**JUNE 5, 2019
BOARD OF COUNTY COMMISSIONERS
ORANGE COUNTY, FLORIDA
ADDENDUM NO. 2, IFB Y19-754-RC
ORANGE COUNTY FIRE RESCUE FIRE STATION #30 HVAC
REPLACEMENT**

THE REVISED BID OPENING DATE IS: JUNE 25, 2019

M-100

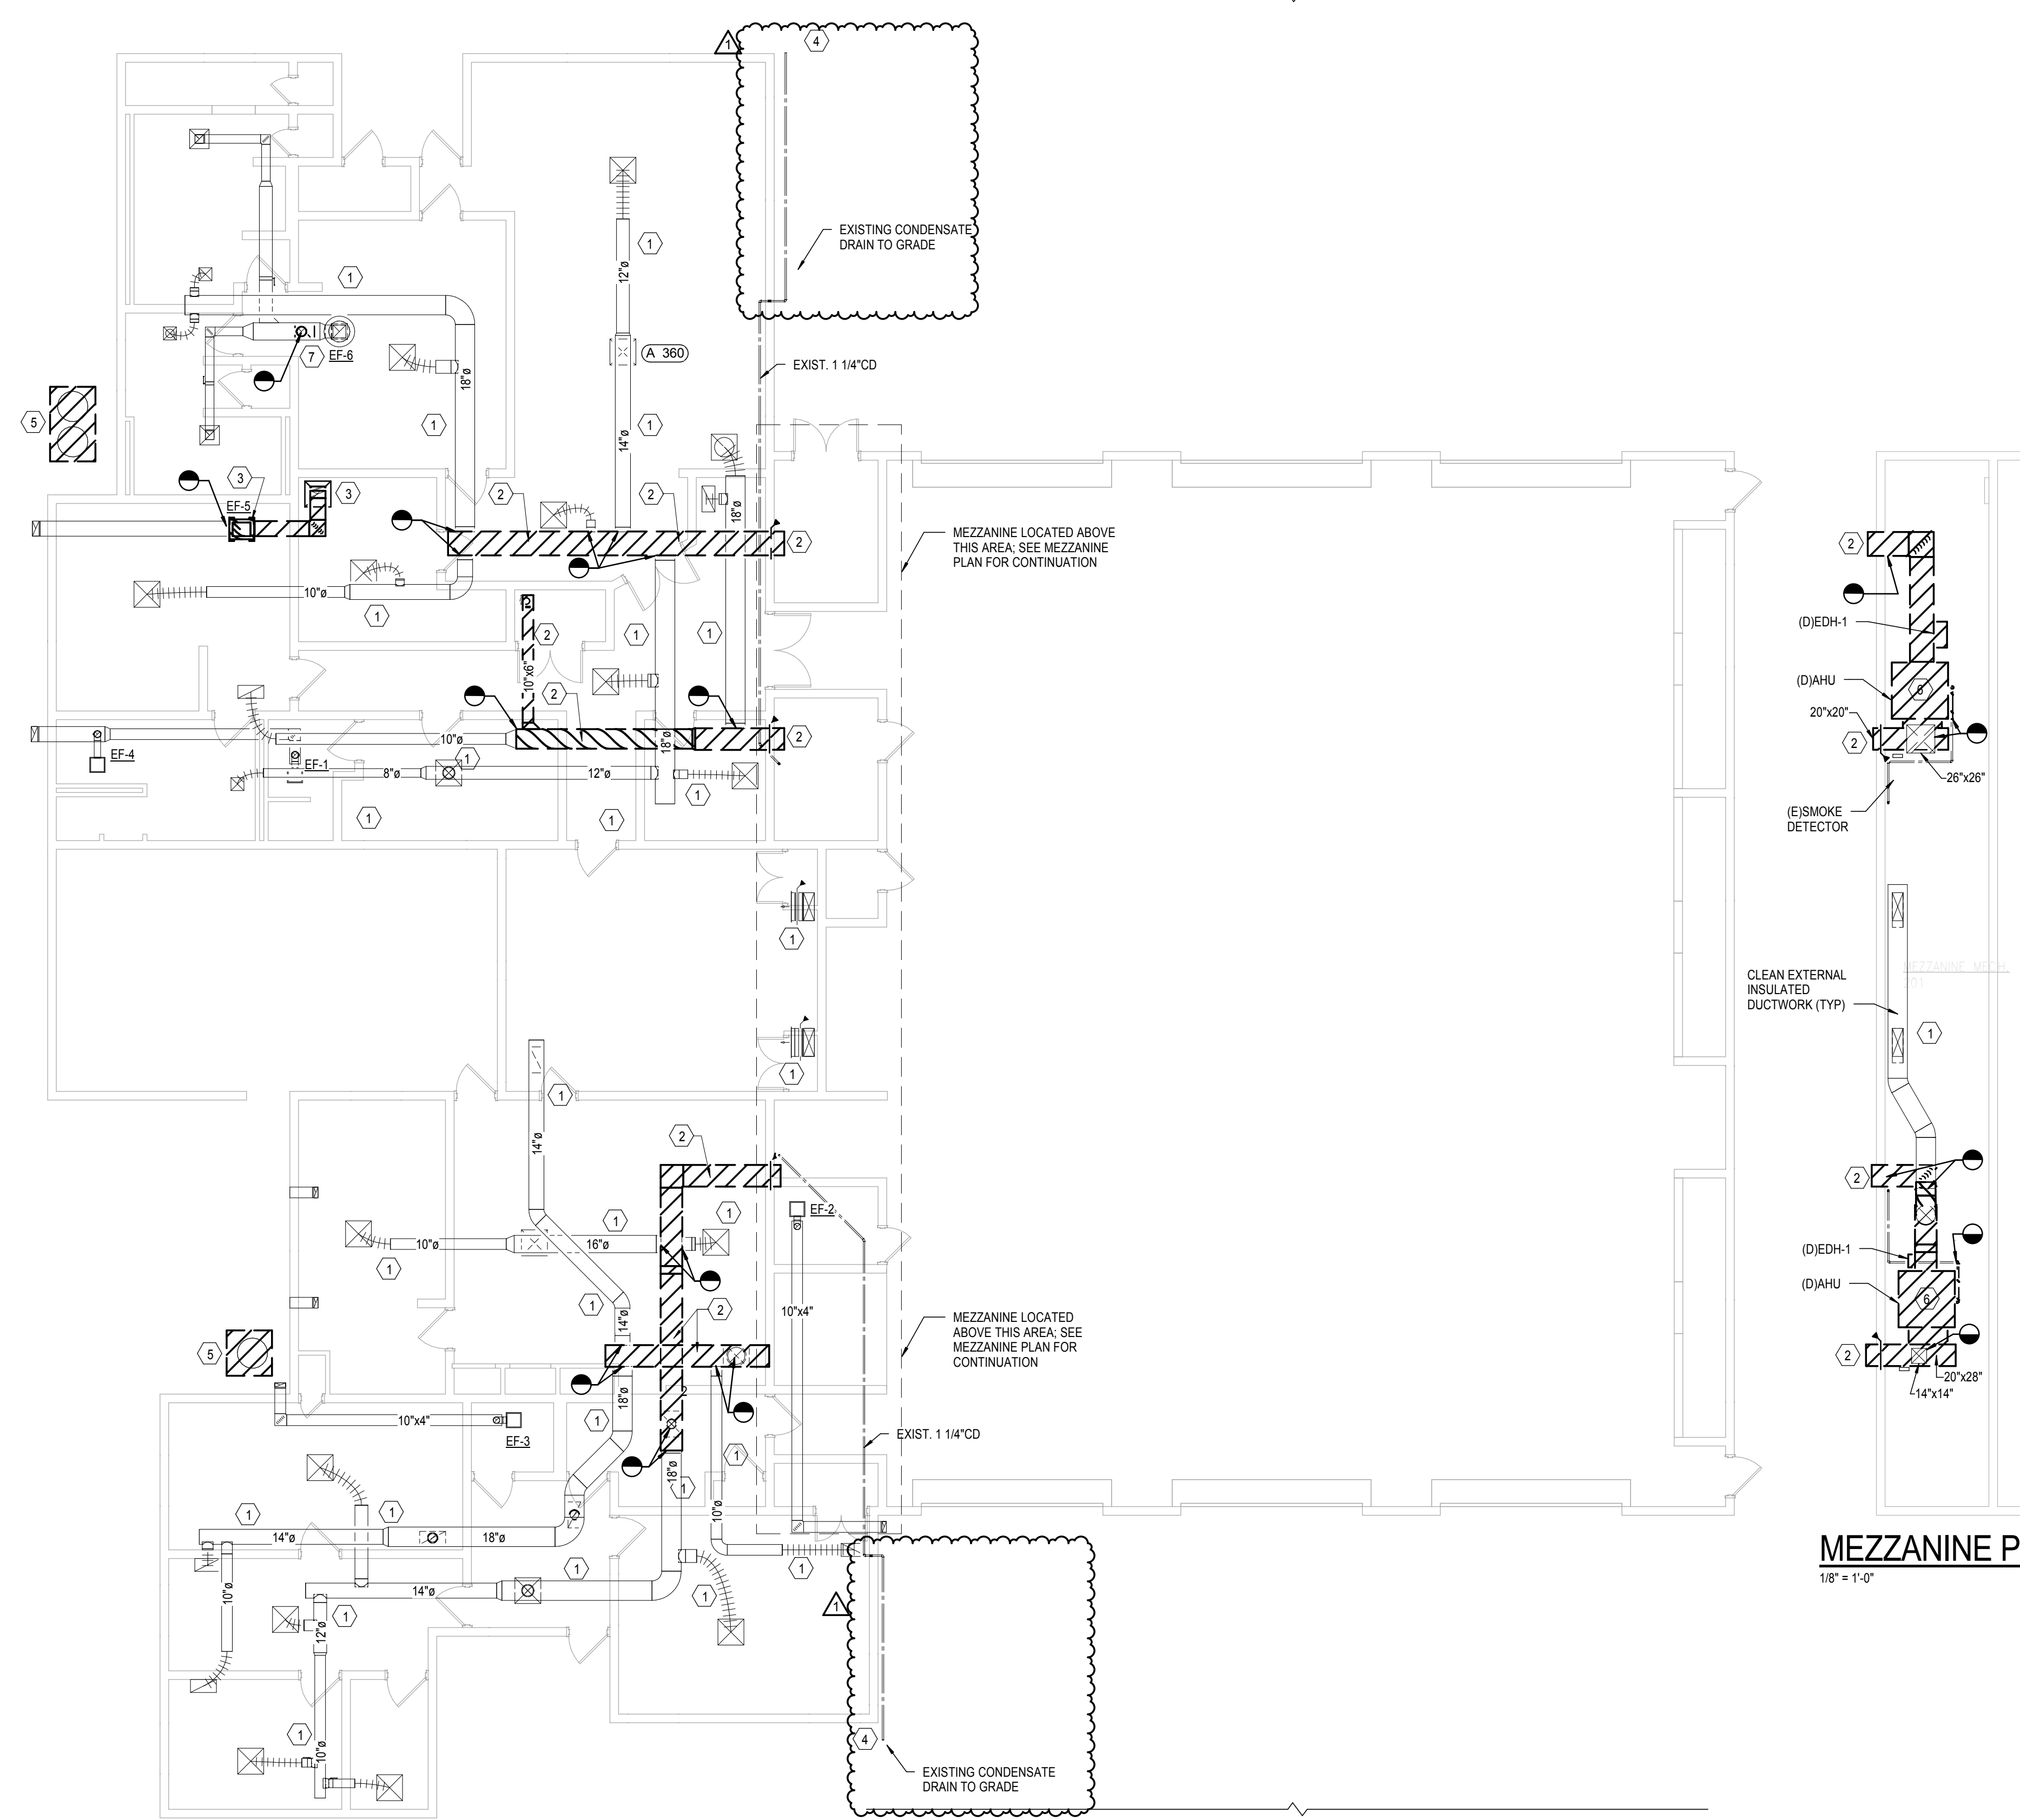
11. QUESTION: Drawing M-100, Plan Key Notes, Note #4 states to remove existing drywells and provide new. It was noticed at the Prebid meeting that from the Hastings Street entrance (east side of building) that the area indicated on the plans as the location of one of the two drywells is under an existing concrete drive way (see attached photos). Is the contractor expected to cut and remove the concrete, which will hinder the fire department from accessing that bay for an indefinite amount of time, to remove and replace the drywell then patch the concrete when finished? If so please provide a specification for that specific drywell to include DOT/traffic ratings. Please provide a detail on how to patch the concrete in this area.

12. QUESTION: For the drywell to be installed on the west side of the facility which is in a non-traffic area will the attached drywell submittal be acceptable? If not, please provide a specification.

ANSWER: Please see revised drawing sheets M-100 and M-101 as well as NDS Flo-Well Drywall Spec.

ANSWER: Please see revised drawing sheets M-100 and M-101 as well as NDS Flo-Well Drywall Spec. Provide drywells in the turfed areas as shown in the revised drawings. The attached "Flo-Well" drywell is acceptable.

4. REMOVE EXISTING CONDENSATE TO GRADE. PREPARE PIPING BELOW GRADE FOR CONNECTION TO NEW DRYWELL EXCAVATE BY HAND AS REPLACED TO AVOID DAMAGE TO EXISTING UTILITIES.

Sheet Number:
A-1.1.4

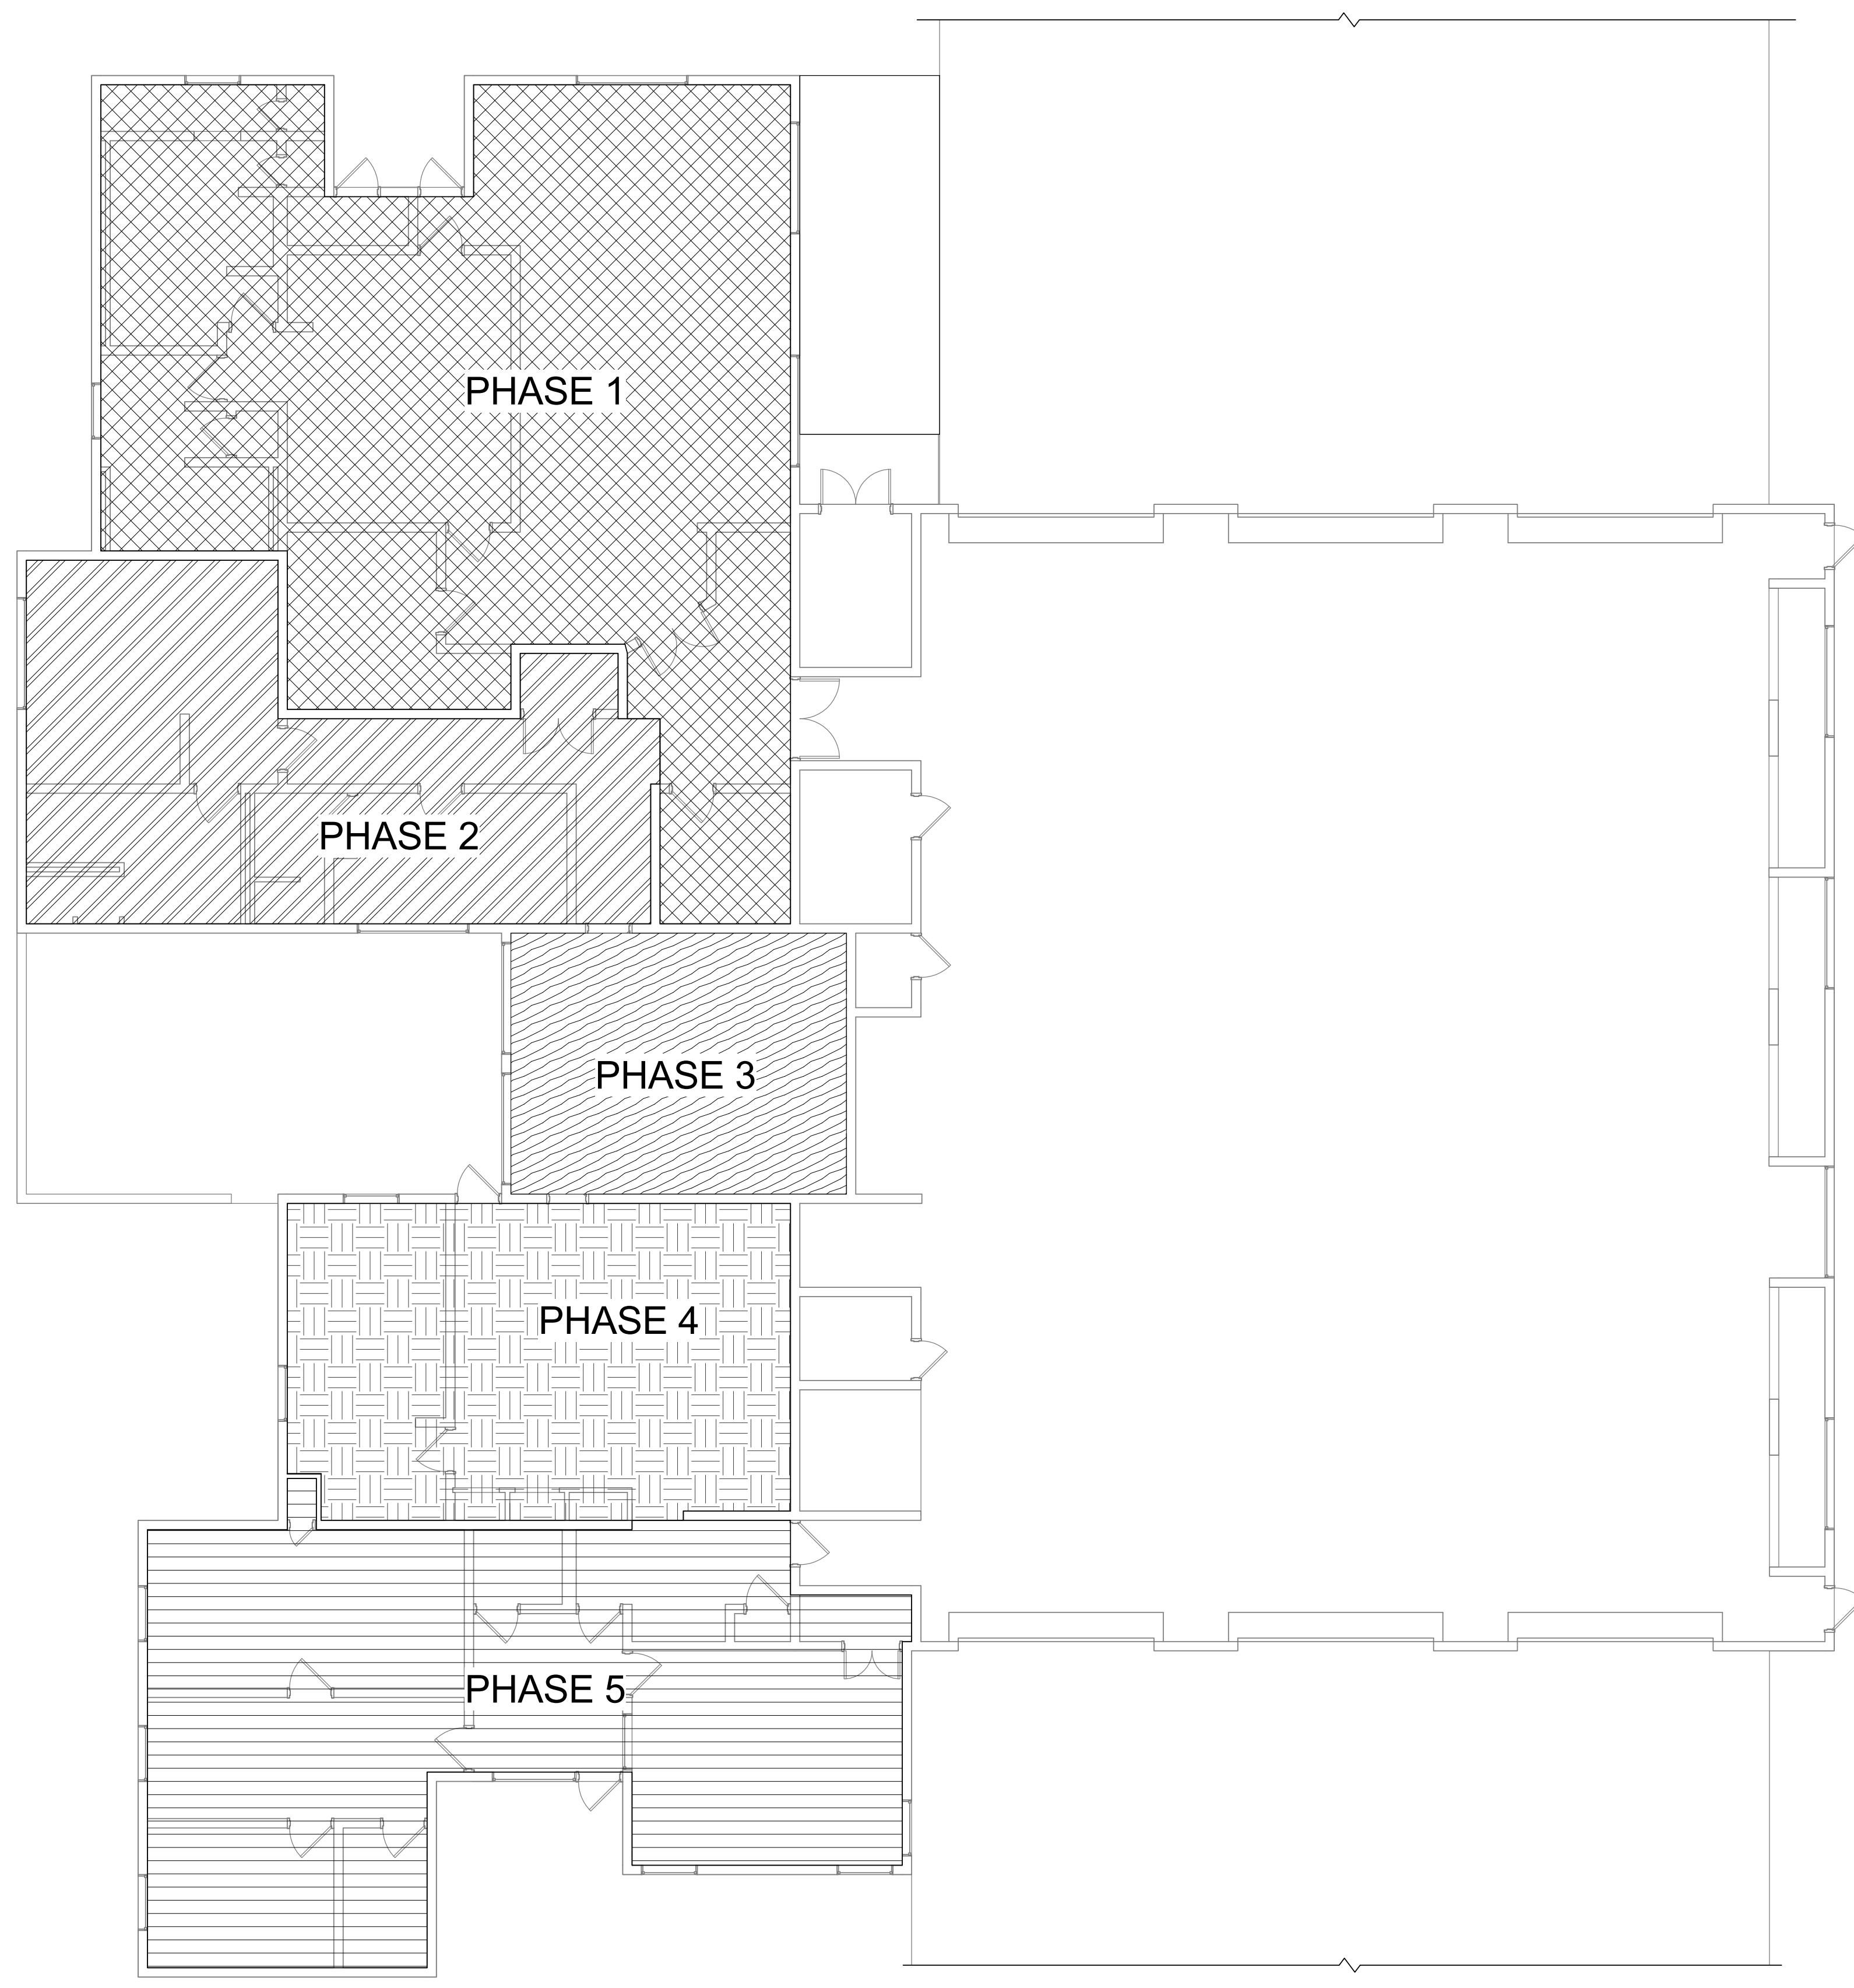
3. QUESTION: Please confirm the contractor will have exclusive access to the areas highlighted on drawing A-1.1.4 during each phase. There is a substantial amount of overhead work to be done inside the Fire Station and this is necessary for the safety of the Fire Fighters

ANSWER: The contractor will have full access within the respective phasing space they are working in at the time.
